Request for Proposals Number: 23-31

Addendum 3

Date: June 16, 2023

PROJECT: SECFEN
PROJECT NAME: Security Gate Replacement
PROJECT CODE: SECFEN
ADDRESS: Various

RHODE ISLAND PUBLIC TRANSIT AUTHORITY

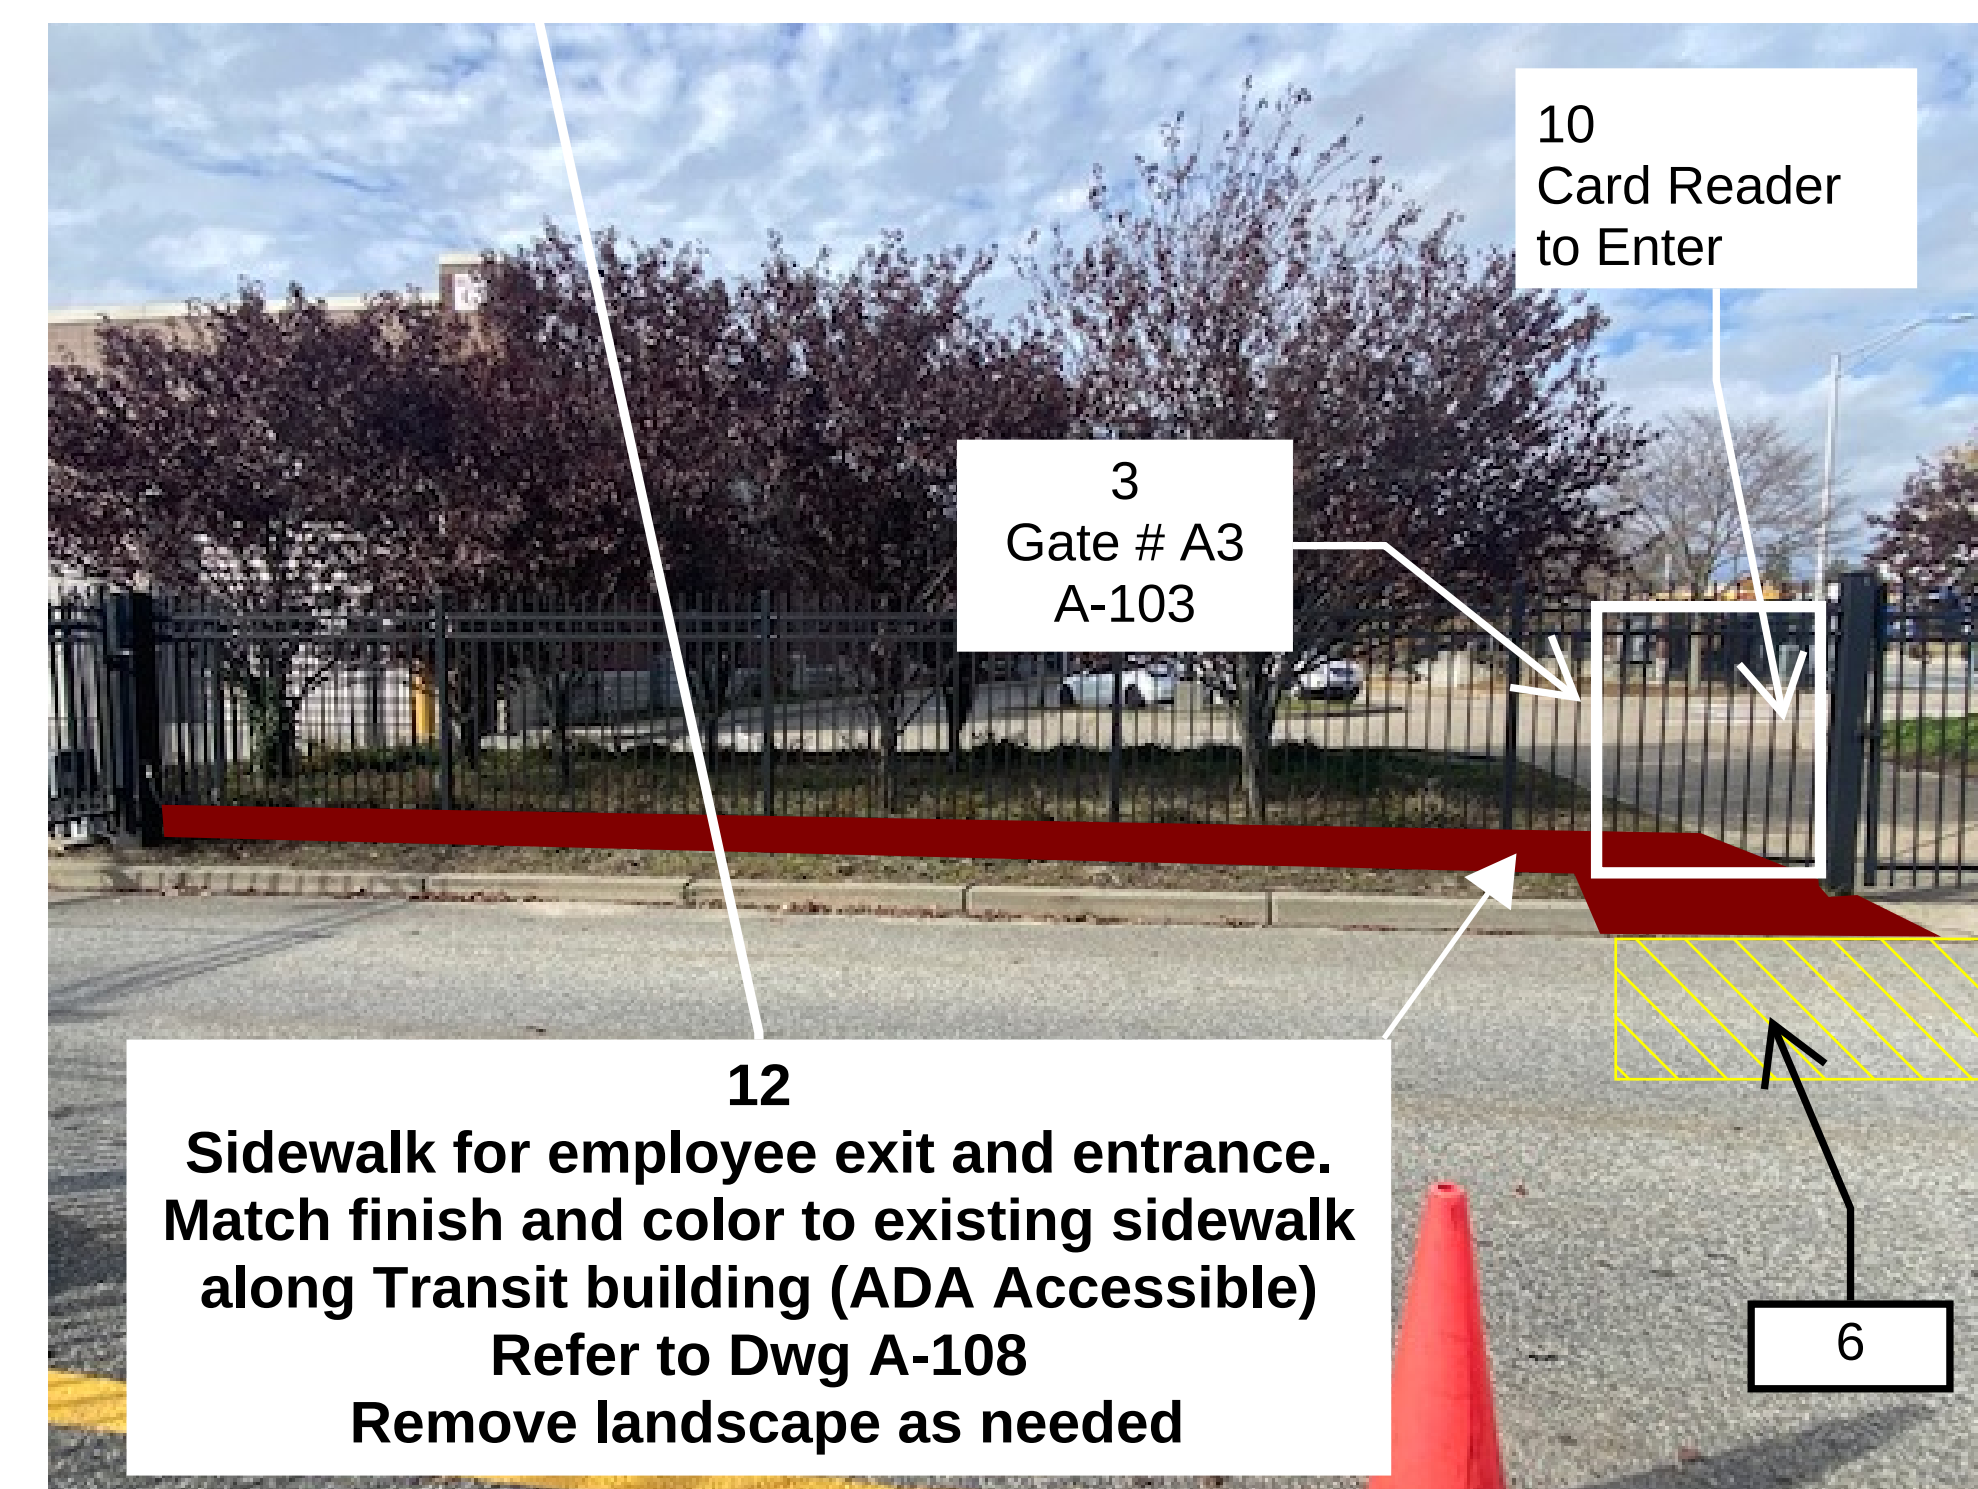
705 Elmwood Entrance	C-203	C	C7			CANTILEVER SIDE GATE DETAILS A-103	NEW	NA	X	NA	X	NA	C-203 / A-106	Relocate island (Surface mount to parking deck) and configure fencing to Widen both gates 18" - Add Security Fence to wall
				C8		CANTILEVER SIDE GATE DETAILS A-103	NEW	NA	X	X	X	NA	C-203 / A-106	
					C9	TUNE-UP Existing Pedestrian Gate	NEW	NA	X	NA	X	Tune up Exisiting Gate	C-203 / A-106	
705 Elmwood Entrance	C-204	D	D10	D10	NA	VERTICAL PIVOT GATE Details A-103	NEW	NA	X	X	YES	NA	C-204 / A-106	New Fence to match existing fence and match height of fence at corner - Remove and dispose of existing gate and footings and pave disturbed area to match existing pavement - Tie new gate into existing electrical
750 Elmwood Entrance from Elmwood	C-205	E	E11	NA	NA	CANTILEVER SIDE GATE DETAILS A-103	Tune up existing	REUSE	Reuse if structurally sound	NA	YES	NA	C-205	
750 Elmwood Exit to Elmwood	C-205	E	NA	E12		CANTILEVER SIDE GATE DETAILS A-103	Tune up existing	REUSE	Reuse if structurally sound	X	YES	NA	See Note	Replace approximately 40 posts only on perimeter Fence. Reuese and repair fencing as needed.

E13	TUNE-UP Existing Pedestrian Gate	NA	NA	NA	NA	NA	TUNE-UP Existing Pedestrian Gate	C-205	
269 Melrose Entrance / Exit to Melrose	C-206	F	F14	F14		CANTILEVER SIDE GATE DETAILS A-103	Tune up existing	REUSE	Reuse if structurally sound	X	YES		NA	Move exit loop further away from gate
					F15	TUNE-UP Existing Pedestrian Gate	NA	NA	NA	NA	NA	Tune up Exisiting Gate	NA	
Ryder Lot Entrance from Cadillac	C-207	G	G16	NA	SEE COMMENTS	CANTILEVER SIDE GATE DETAILS A-103	Tune up existing	REUSE	Reuse if structurally sound	NA	YES	See Comments	C-207	Pedestrian Gate to remain and secured by owner
Ryder Lot Exit onto Longfellow	C-208	G	NA	G17	NA	CANTILEVER SIDE GATE DETAILS A-103	Tune up existing	REUSE	Reuse if structurally sound	X	X	NA	NA	Rework sidewalk to accomodate bus turn radius
Employee Parking Lot Melrose Exit - Entrance	C-209	H	H18			CANTILEVER SIDE GATE DETAILS A-103	NEW	REUSE	NEW and Reuse existing if possible	NA	X	NA	C-209	Reconfigure Entracne / Exit so vehicles can make a safe turn thru the gates

H19		CANTILEVER SIDE GATE DETAILS A-103	NEW	NEW	NEW	X	X	NA	C-209	
					H20	RELOCATE AND TUNE-UP Existing Pedestrian Gate	NA	NA	NA	NA	NA	Relocate Pedestrian Gate H-21	C-209	
Newport Facility	C-210	I	I-21	I-21		SLIDE ENTRANCE GATE DETAILS A-103	NEW	NEW	NEW	Open 1/2 way on exit	X	NA	See note	ADD Security Fence from new gate to existing Security Fence - One Slide Gate with new support posts. (do not remove existing support poles) Gate to be moved in towards the building approximately 4' (tbd) - OPEN HALLE WAY ON EXIT
					I22	2150 Style Pedestrian Swing	NA	NA	NA	NA	NA	2150 Style Pedestrian Swing	See Note	Add 8' wide Utility Gate (2) 4' swing gates

GATE A1, A2, A3

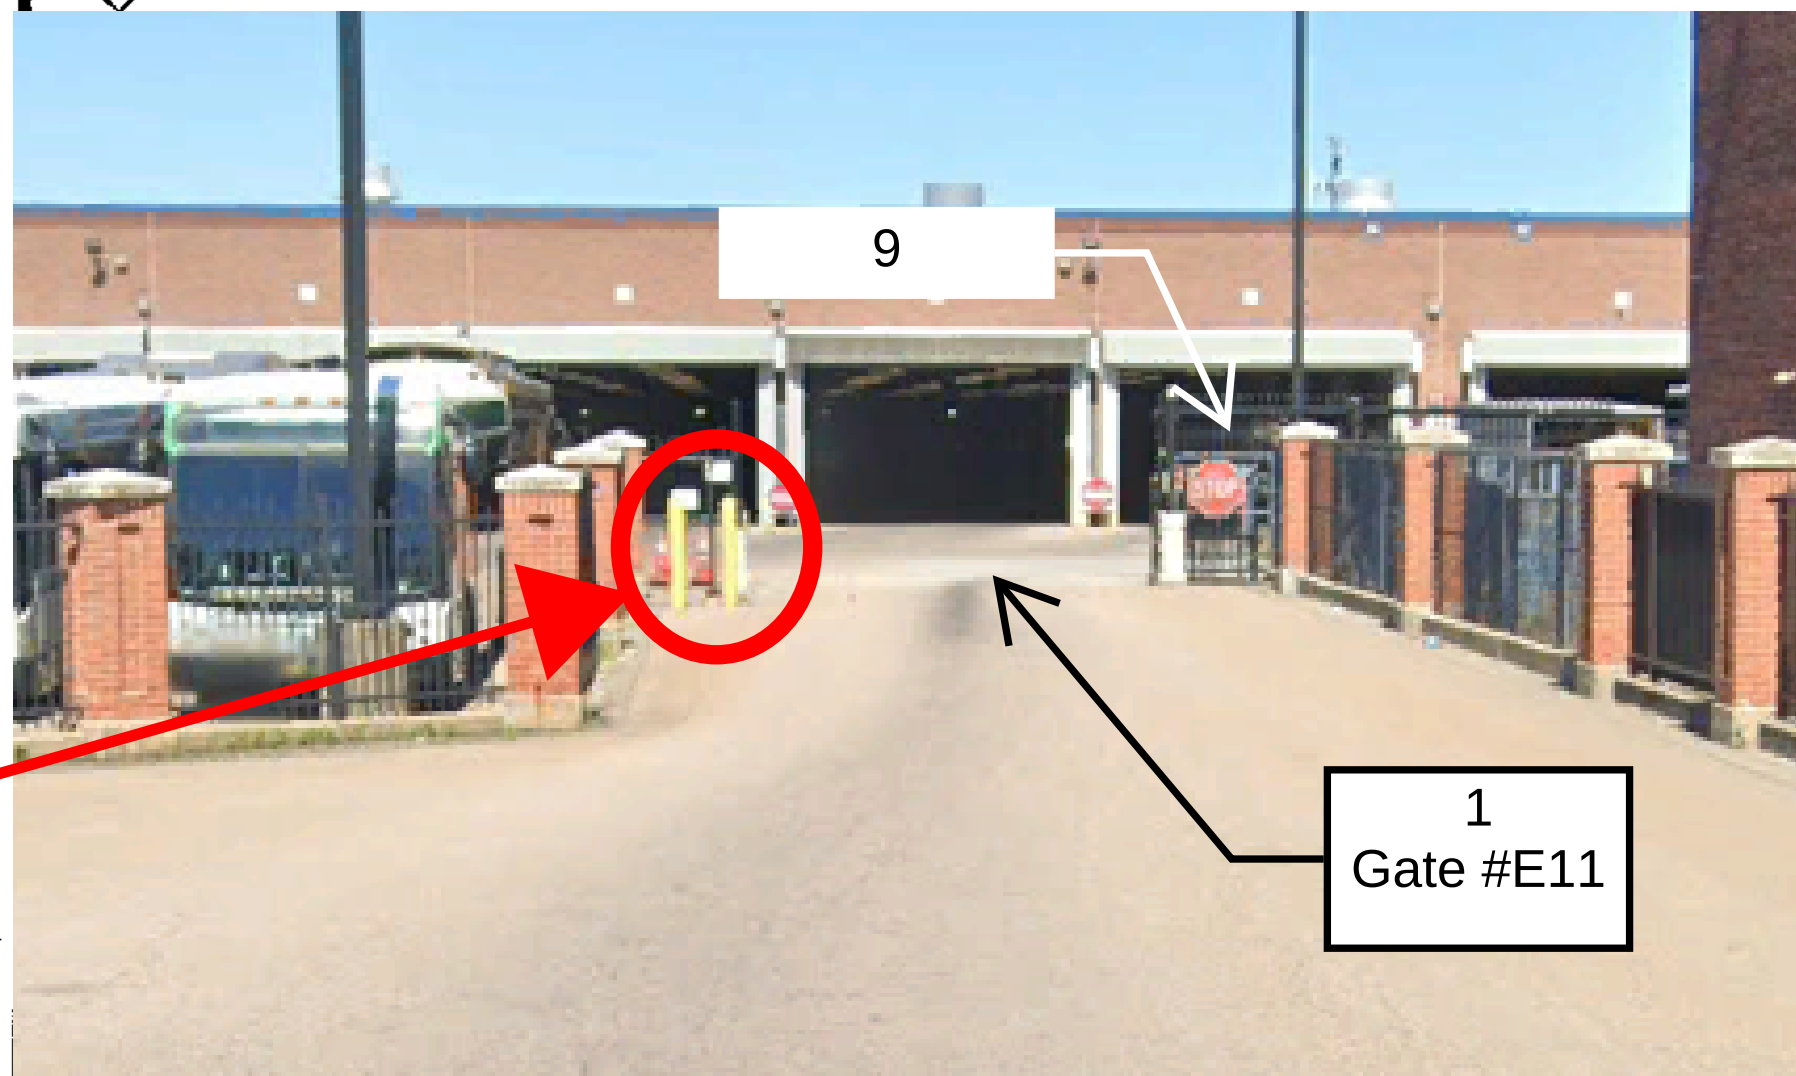
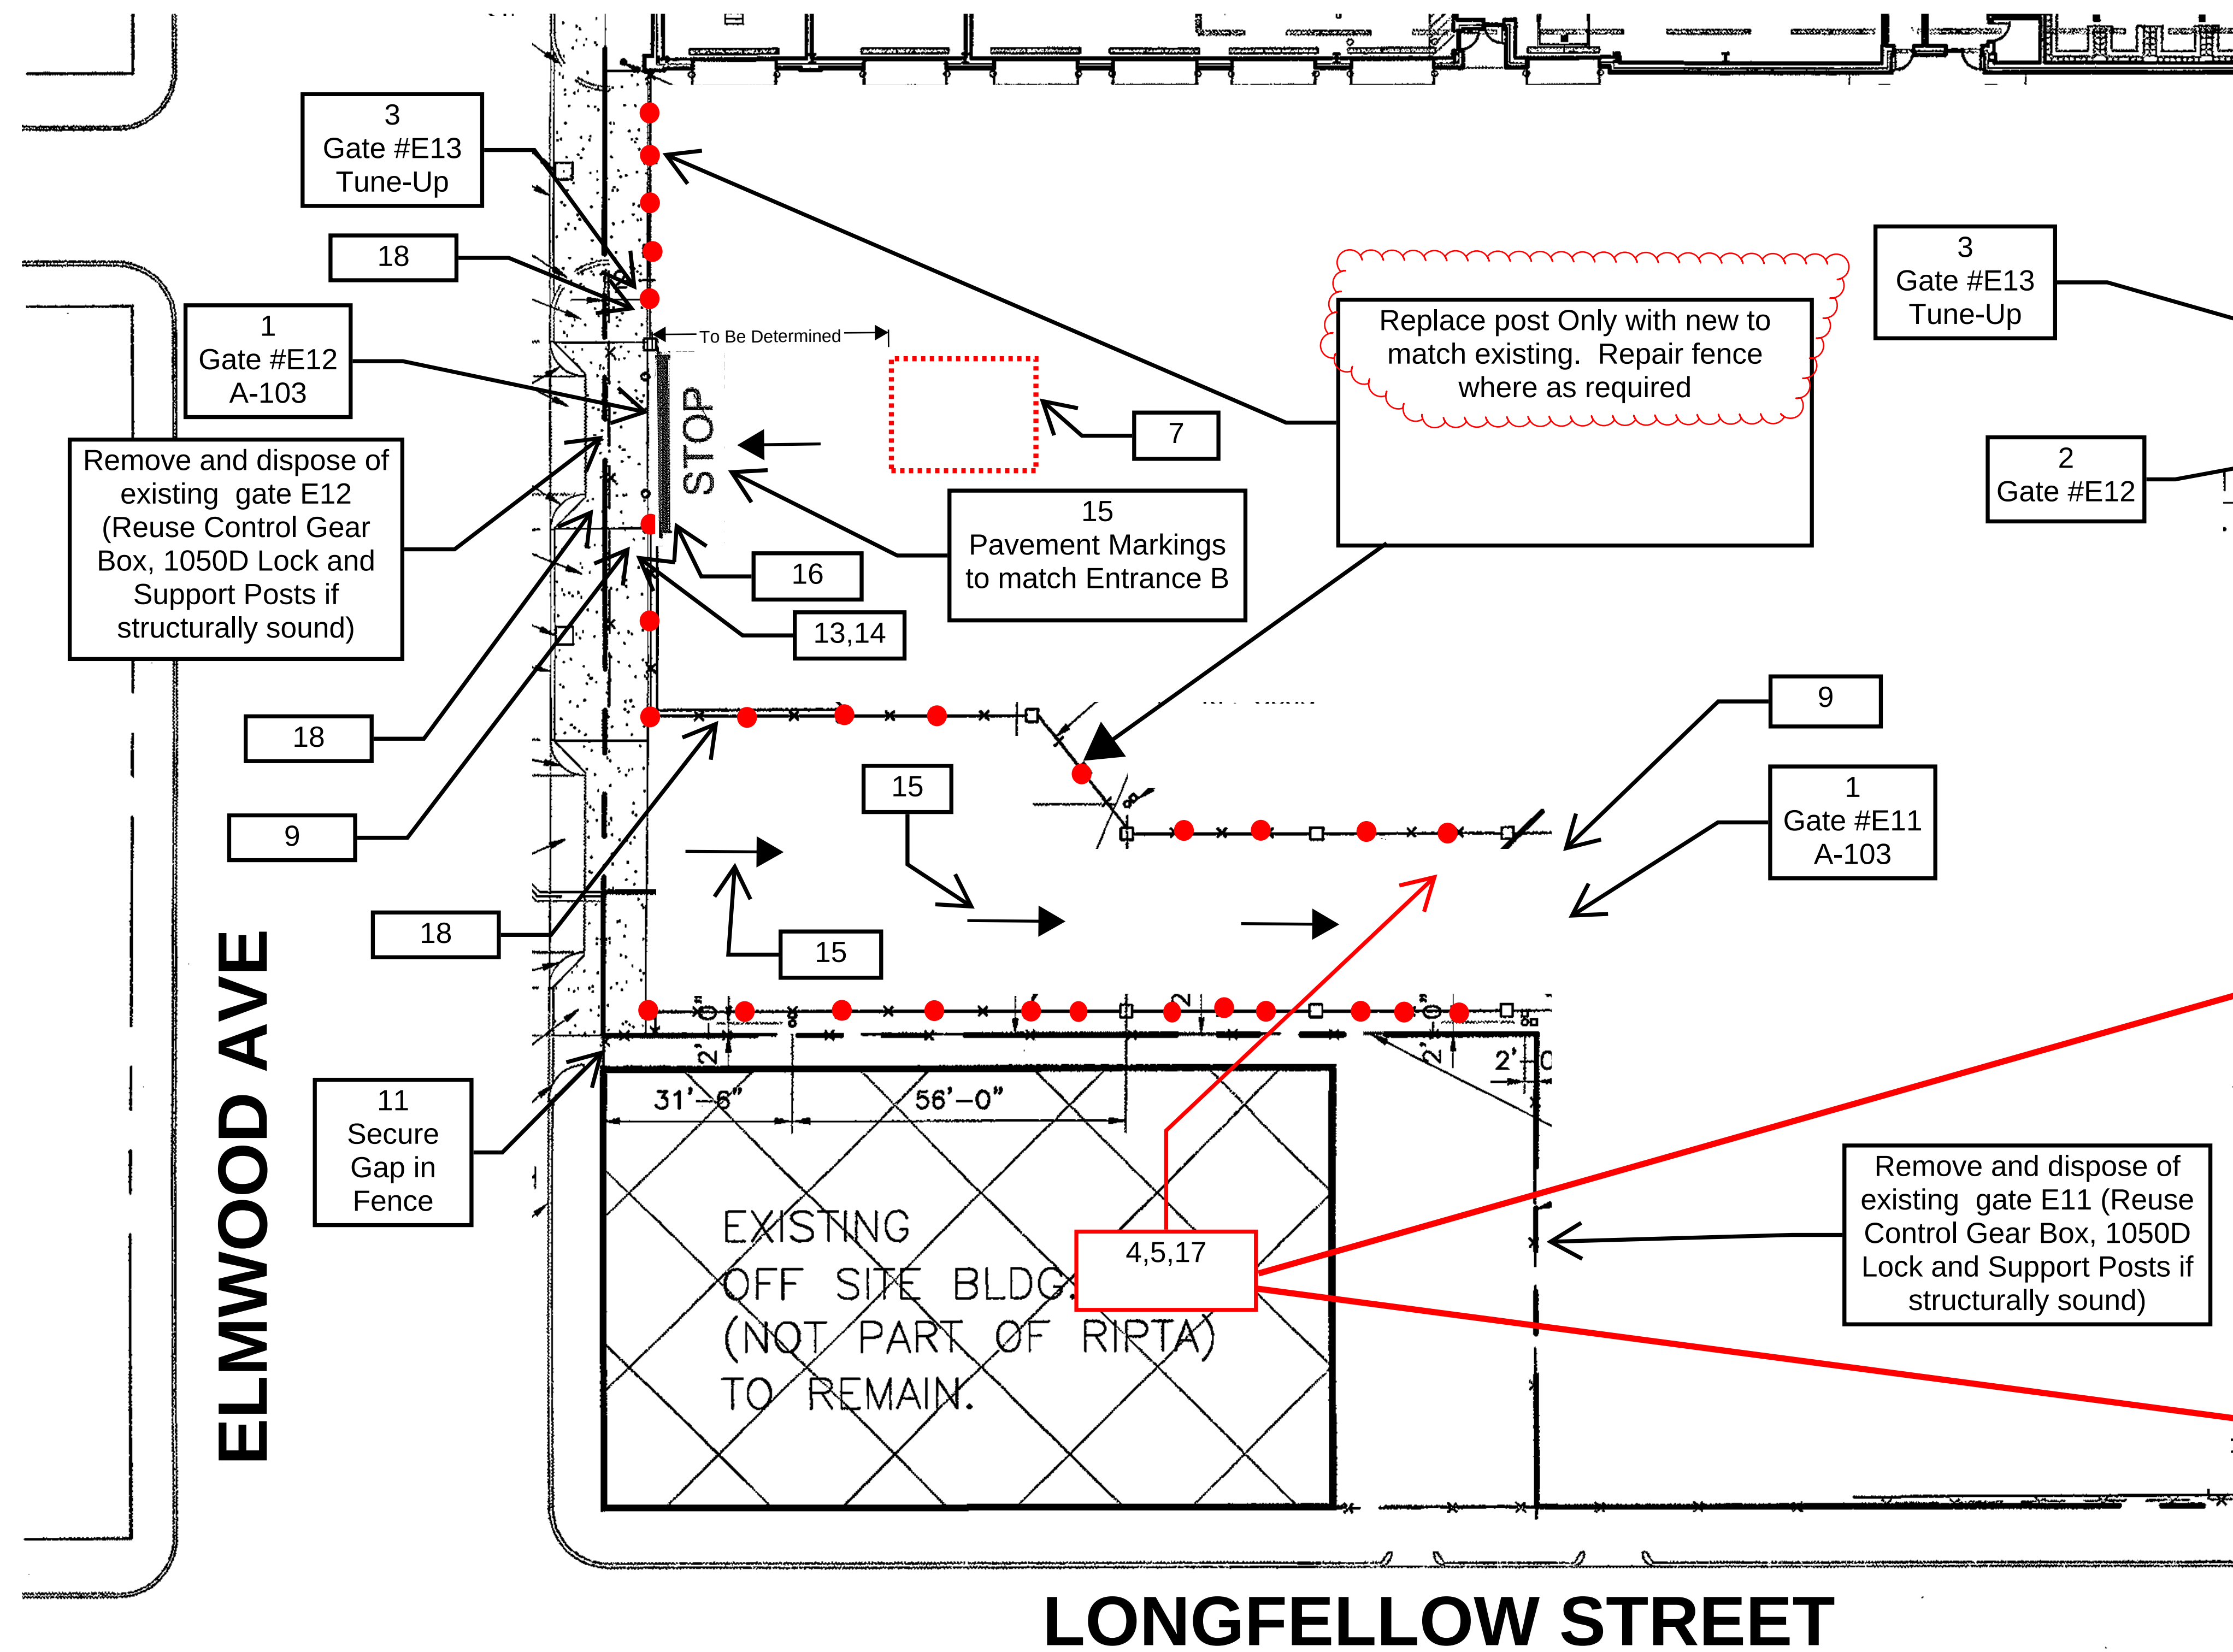
12
Sidewalk for employee exit and entrance.
Match finish and color to existing sidewalk
along Transit building (ADA Accessible)
Refer to Dwg A-108
Remove landscape as needed
